ADDENDUM NO.: 3.0

DATE OF ADDENDUM: October 29, 2014

**Founders Hall Renovations for Allied Health and Nursing
Naugatuck Valley Community College, Waterbury, Connecticut
BI – CTC – 442 – CMR**

SKETCH TITLE
 ADDITIONAL LAYOUT FOR
 JOINTS AT BOLLARDS

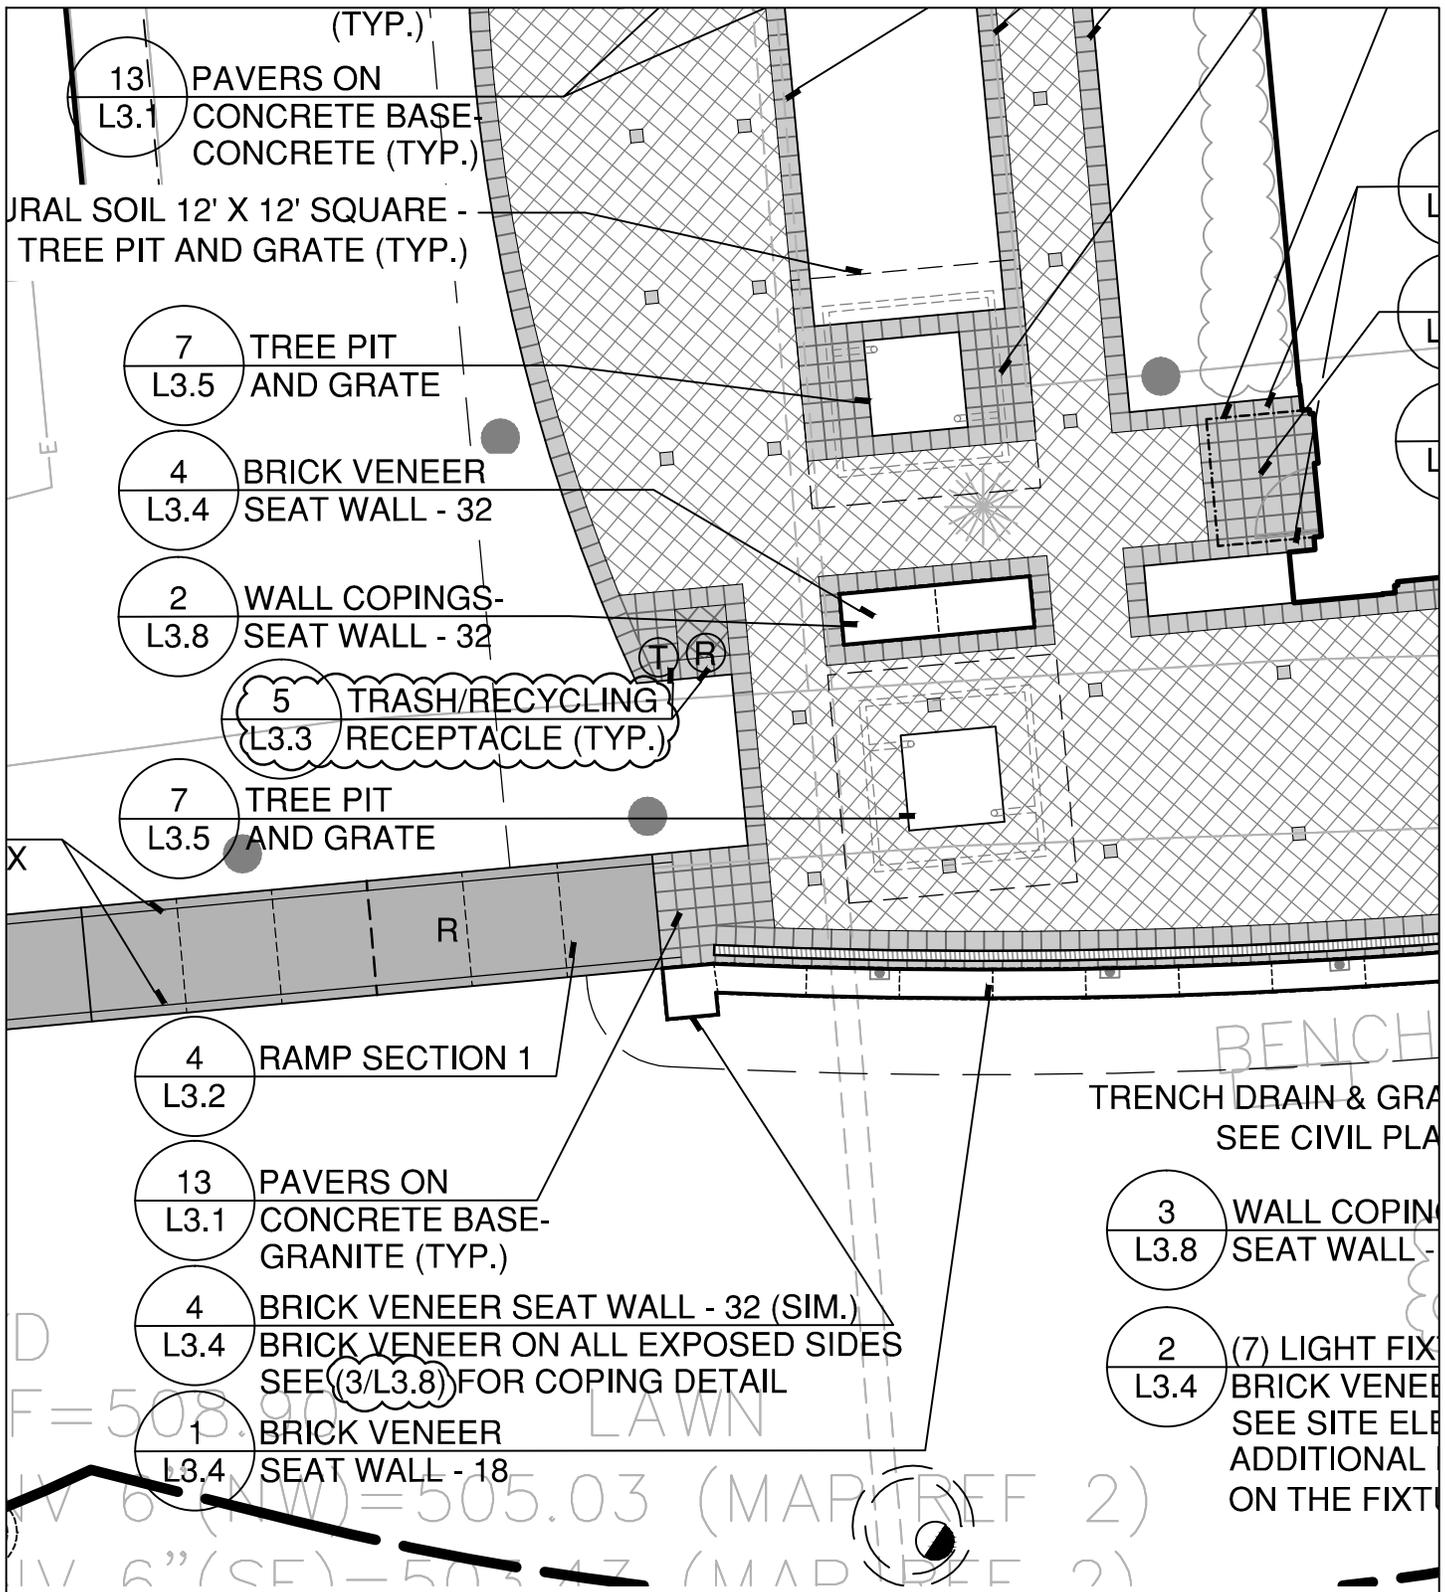
DRAWING L1.2 – SITE IMPROVEMENTS PLAN: **ADD** dimensions near main entrance as indicated on attached sketch AD3-SK-L-1.2-1 titled "Additional Layout for Joints at Bollards".

SKETCH TITLE
 CORRECTED DETAIL

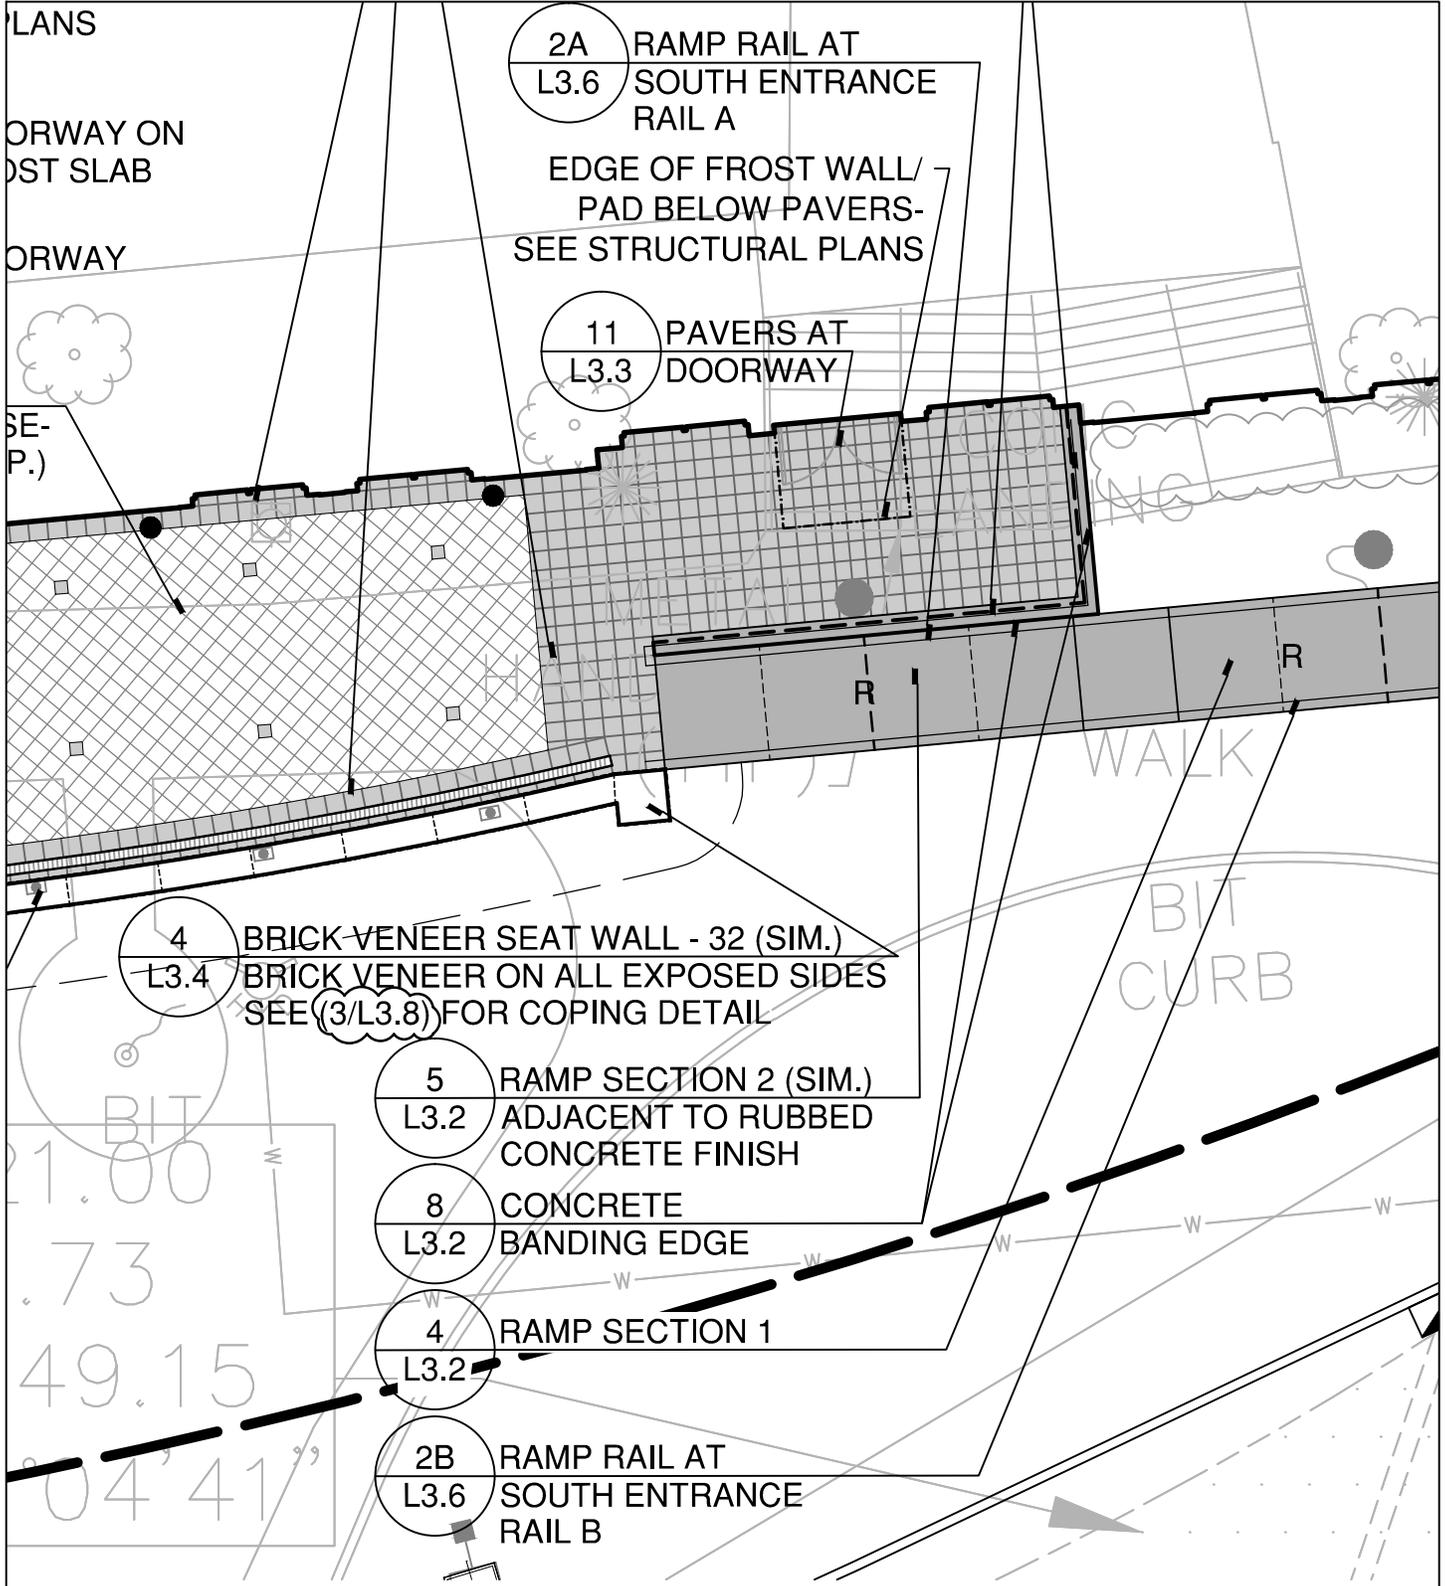
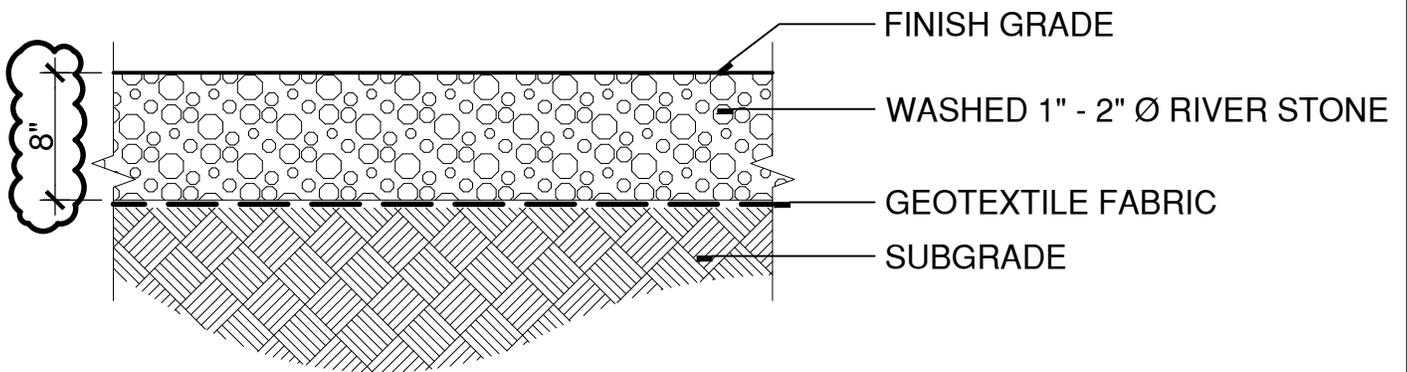
DRAWING L2.2 – SITE IMPROVEMENTS ENLARGEMENT: At Main Entry & Terrace detail 1, **REVISE** detail call outs as indicated on attached sketches AD3-SK-L-2.2-1 and AD3-SK-L-2.2-2 both titled "Corrected Detail References".

DATE	10/29/2014
COPYRIGHT ©	Moser Pilon Nelson Architects
SCALE:	NTS
SKETCH NO.	AD3-SK-L3.1-1

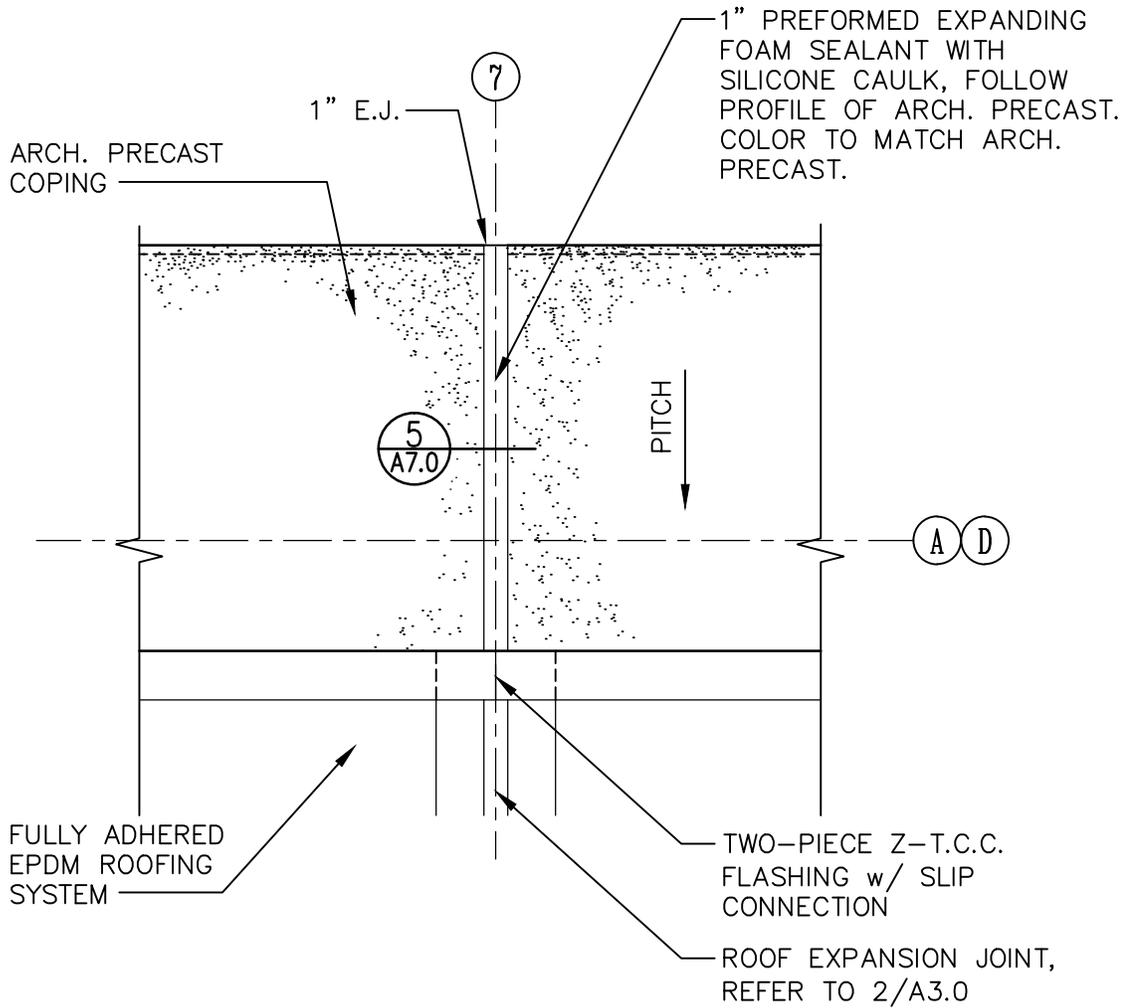
DRAWING L3.1– SITE DETAILS: At detail 14, **ADD** dimension as indicated on attached sketch AD1-SK-L3.1-1 titled "River Stone Surface Added Depth Dimension".

C.J. @ BRICK VENEER

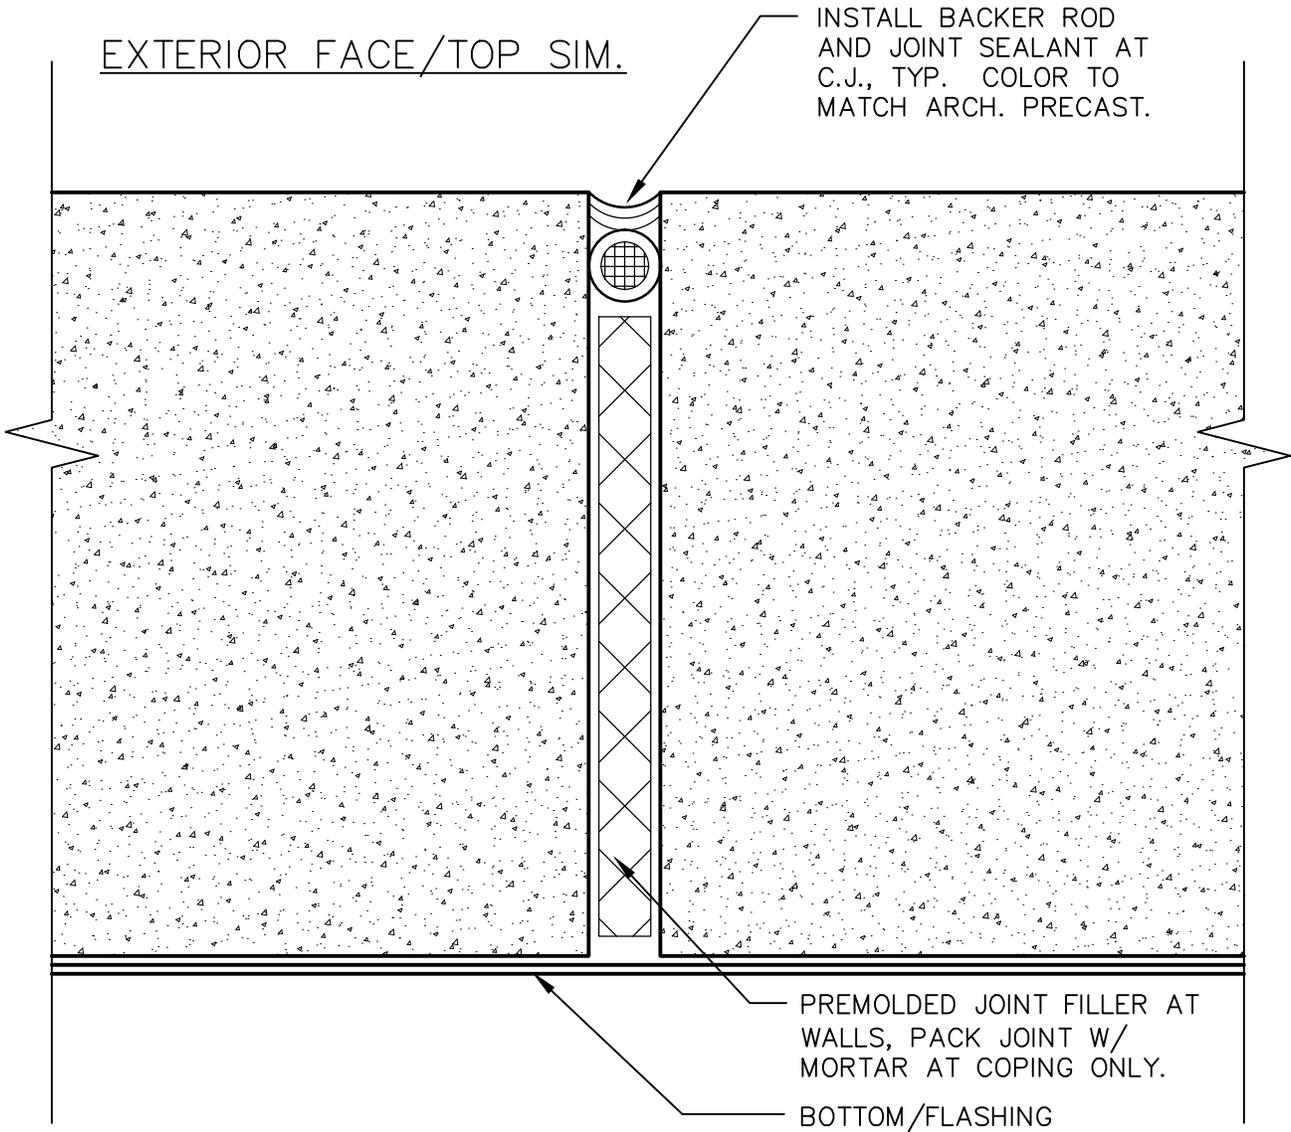
- a. **ADD** wall type 18B consisting of 5/8” gwb one side 8” metal studs at 16” o.c.
- b. **ADD** plan detail 2 at control joint in brick veneer as shown on attached sketch AD3-SK-2/A7.0.
- c. **ADD** detail 3 at control joint in precast concrete coping as shown on attached sketch AD3-SK-3/A7.0.
- d. **ADD** detail 4 at expansion joint in brick veneer as shown on attached sketch AD3-SK-4/A7.0.
- e. **ADD** detail 5 at expansion joint in architectural precast concrete as shown on attached sketch AD3-SK-5/A7.0.

SKETCH NO.
 AD3-SK-EL1.1B-1

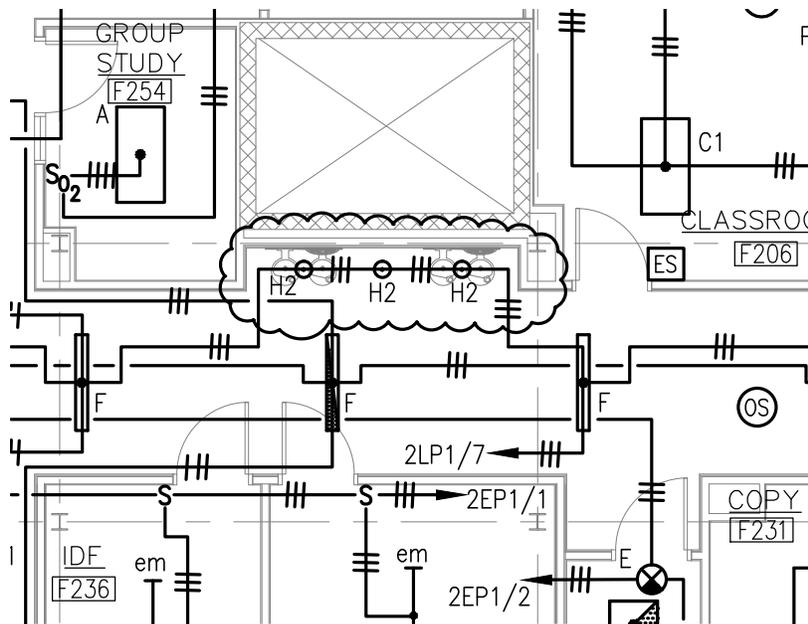
DRAWING EL1.1B – MAIN LEVEL FLOOR LIGHTING PLAN - NORTH: At water coolers in Corridor F155 **REVISE** the three type H1 light fixtures to type H2 light fixtures per attached sketch AD3-SK-EL1.1B-1.

SKETCH NO.
 AD3-SK-EL1.2B-1

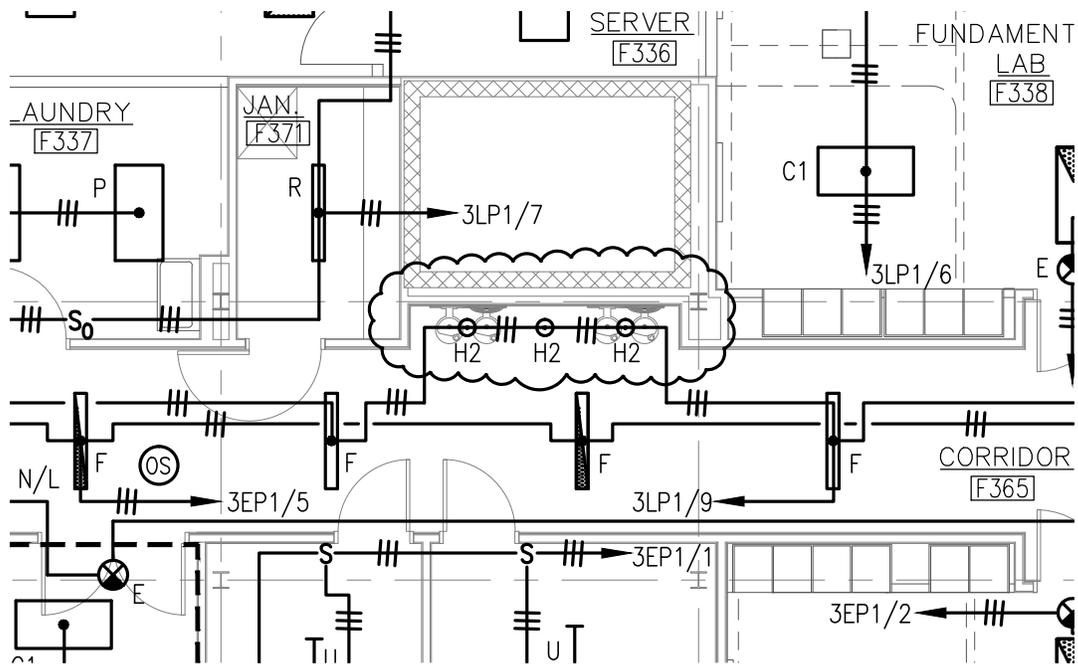
DRAWING EL1.2B – SECOND FLOOR LIGHTING PLAN - NORTH: At water coolers in Corridor F246 **REVISE** the three type H1 light fixtures to type H2 light fixtures per attached sketch AD3-SK-EL1.2B-1.

SKETCH NO.
 AD3-SK-EP1.1A-3

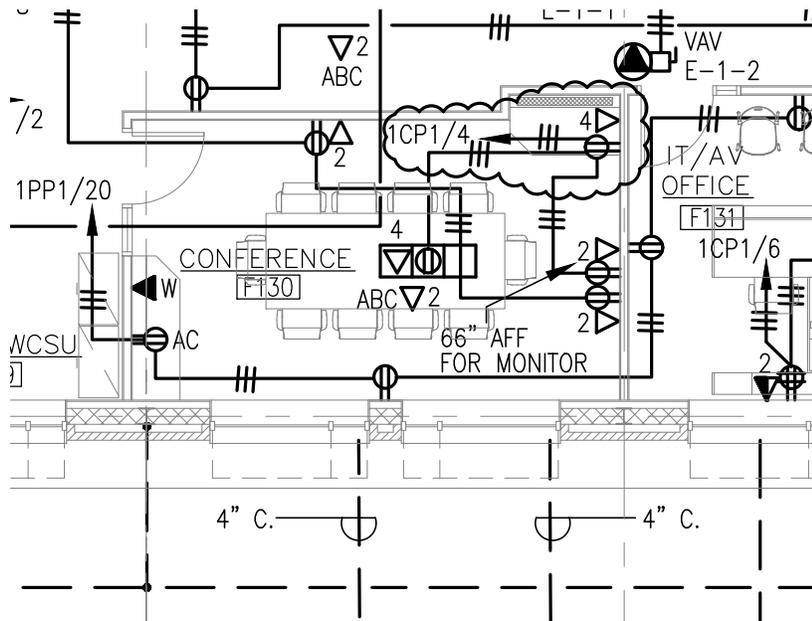
- a. **ADD** “AC” abbreviation (indicating ‘above counter’) to outlet west of opening from Lobby into Food Service F103.
- b. **REVISE** miscellaneous power/data items in Lecture Hall and related spaces per attached sketch AD3-SK-EP1.1A-1.
- c. At Breakout F143 **REVISE** height of monitor per attached sketch AD3-SK-EP1.1A-2; **ADD** “see interior elevations for location” to end of note referencing data/electrical outlets for monitor.
- d. **REVISE** miscellaneous power/data items in Lobby per attached sketch AD3-SK-EP1.1A-3.
- e.
